**PLANNED UNIT DEVELOPMENT  
& SUBDIVISION STAFF REPORT****Date: July 20, 2017****DEVELOPMENT NAME**

Rangeline Crossing III Subdivision

Planned Unit Development Approval to amend a previously approved Planned Unit Development to allow shared access between multiple lots, and Subdivision Approval to create 3 lots.

# DETAIL SITE PLAN

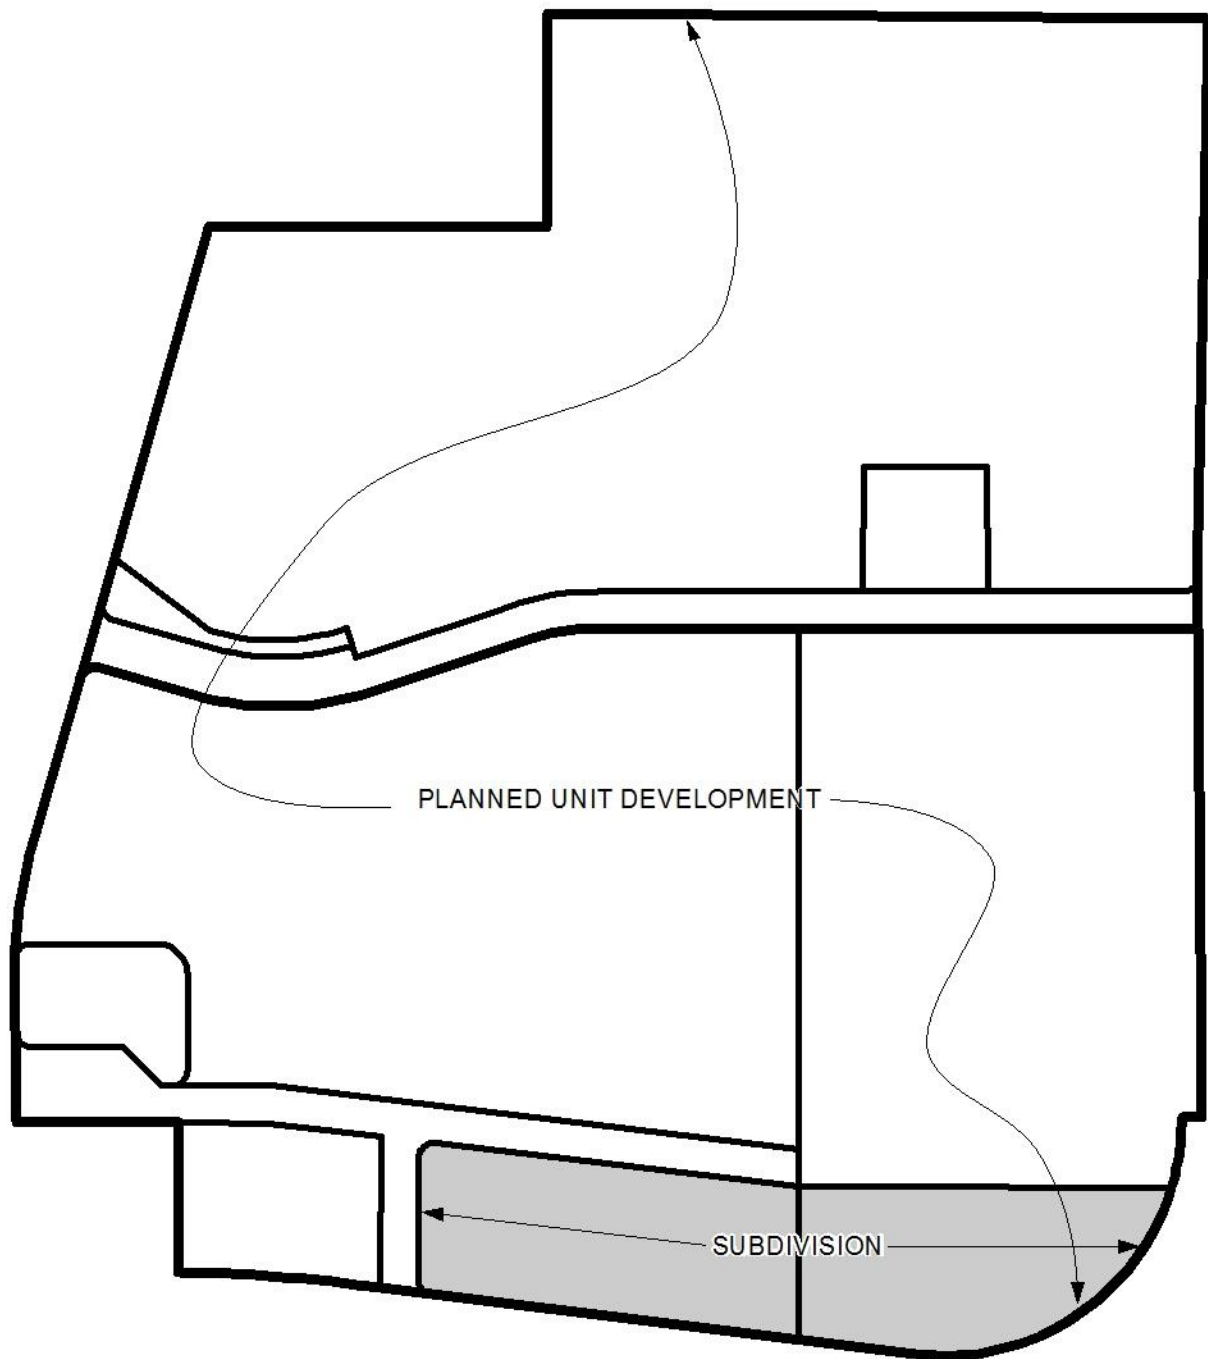
DELETE PUD NOTES #1 AND #2 SINCE THEY CONFLICT WITH CITY COMPLIANCE NOTES #2 & #3

RENUMBER THE CITY COMPLIANCE NOTES #4 - #10 SO THAT THERE ARE NOT TWO (2) #4 NOTES.

The PUD site plan depicts Lot B as having a fast food restaurant developed on the site with compliant parking and queuing spaces; however the dumpster is located with the 25' minimum building setback line. The site plan should be revised to depict the relocation of the dumpster so that it is not located within the setbacks. The site plan should also be revised to include a note stating "full tree planting and landscape requirements will be meet and in compliance with Section 64-4.E of the Zoning Ordinance".

Several drainage, access and utility easements are depicted on the preliminary plat and the PUD site plan. A note should be placed on both the plat and the site plan stating that structures that are not associated with the purpose of the easement shall not be placed within any easement.

It should be pointed out that the newly proposed PUD site plan does not reflect the previously approved site plan and plat in that the layout of the proposed private road (Rangeline Crossing Drive) has changed. The new proposed location of the private road depicts significant changes that effect Lots 1 and 2 of the Rangeline Crossing Subdivision approved on May 4<sup>th</sup>. As such, the previous approved plat must be revised to reflect the new location of the proposed private road. Therefore the current applications must be heldover to allow a revised application to be submitted for subdivision approval to allow consistency among the plats and site plans.

1. submission of a revised subdivision application to address the new location of the proposed private road and the resulting changes to Lots 1 and 2.
2. revision of the site plan to remove the dumpster outside of the 25' minimum building setbacks;
3. add a note to the site plan stating full tree planting and landscape requirements will be met and in compliance with Section 64-4.E of the Zoning Ordinance; and
4. add a note to both the plat and the site plan stating that structures that are not associated with the purpose of the easement shall not be placed within any easement.
